## Change Order, Construction Manager as Adviser Edition

PROJECT: (name and address)
Christian County High School

Change Order Number: 088

### PROPOSAL REQUEST

A1.1F Rev2

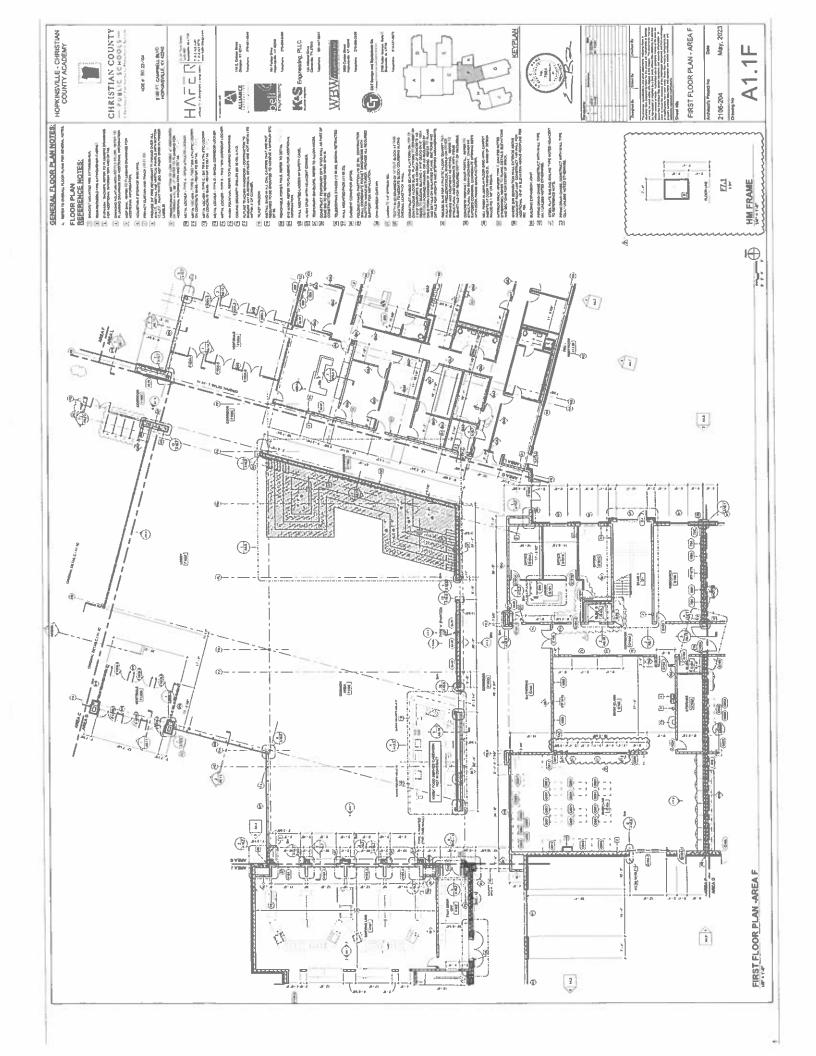
**G102 Interior Windows**

- Provide a price to provide to:
  - Saw Cut openings for three new windows between G102 and G104. Verify dimensions so data feed from above to G102 will not be severed.
  - Provide three new windows similar to W7, but with 8 ¾" depth on knockdown frames for ease of installation and to cover cut edges of CMU
  - · Paint window frames.
  - Provide back to back 3 ½" x 3 ½" x ¼" steel angle lintel at header, bearing 8" each side.
